THE VILLAGE SUBDIVISION

PRELIMINARY OVERALL AREA
DEVELOPMENT PLAN

Re: The Villages Subdivision (Amendment)

POADP # 473-A

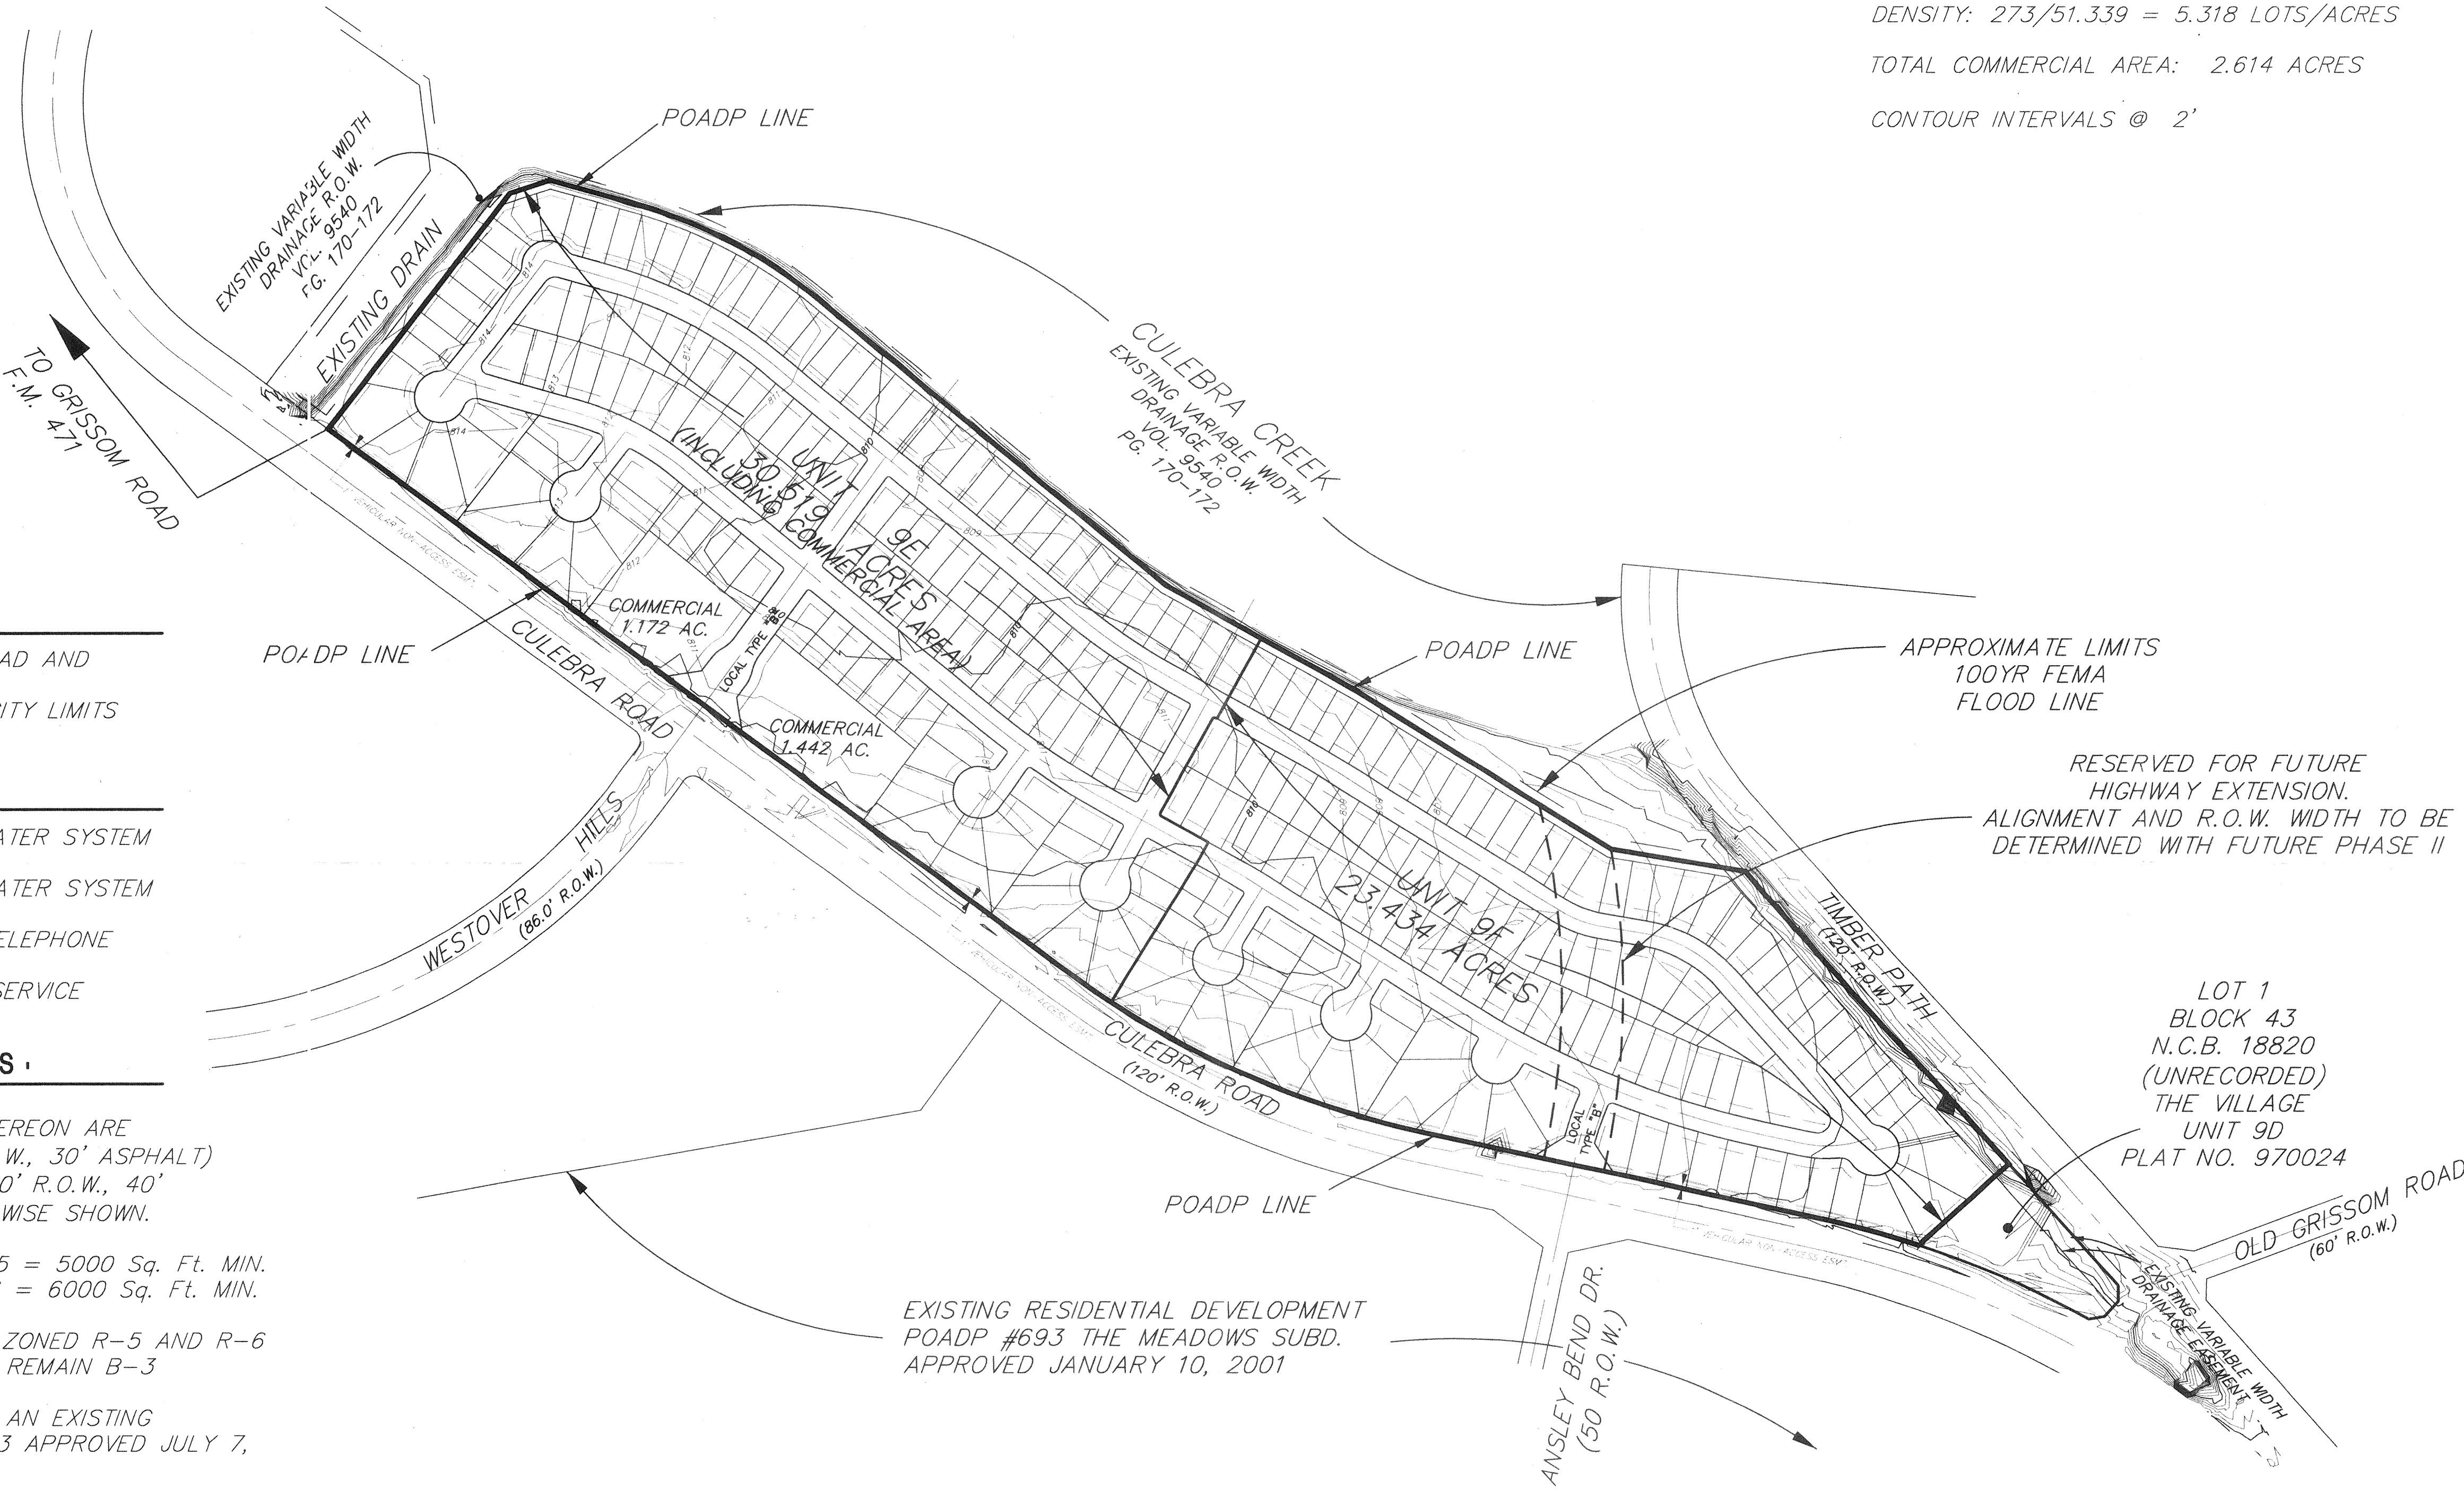
1. The developer has agreed to reserve the right-of-way for the future re alignment of Timber Path. This re-alignment shall be directly aligned with Ansley Bend through this property. The reserved right-of-way and notation is shown on the POADP.

2. The intersection of Culebra Road and Westover Hills Shall comply with the Texas Manual on Uniform Traffic Control Devices for partial traffic signal installation. (Unified Development Code (UDC), Article V, Division 2, Section 89, §(k) et. Seq.)

3. The internal street design for this subdivision shall be in compliance with UDC, Article V, Division 4, Section 139, § (b) (3) et. Seq: "If the anticipated traffic volume at the midpoint of the Street is less than or equal to 500 vehicles per day, then the Street length shall not exceed twelve-hundred (1200) feet."

4. Due to high speed and number of peak hour trips entering this development, the City of San Antonio recommends a dedicated northbound right-turn deceleration lane on Culebra Road at the intersection of Westover Hills.

Coordinate tree preservation. Utilize Culebra creek as
greenbelt w/ houses facing ' neighborhood connection
recommended.

Comments: Provide 1' Abn Access Easement on Culvert.

Comments: CULEBRA RD IS ON THE MTP AND TXDOT SYSTEM
REQUIRING A MIN. OF 110' RDA AND TXDOT RELEASE

Comments: COORDINATE DEVELOPMENT WITH CULEBRA
CREEK FLOODPLAIN LUMP - BROWN ENGINEERING
2001. THIS MAY IMPACT YOUR LOT LAYOUT.

THE LEON CREEK MASTER DRAINAGE PLAN HAS
IDENTIFIED A FLOODING PROBLEM (C-8) IN
THIS AREA. COORDINATE INVESTIGATION WITH
STORM WATER ENGINEERING
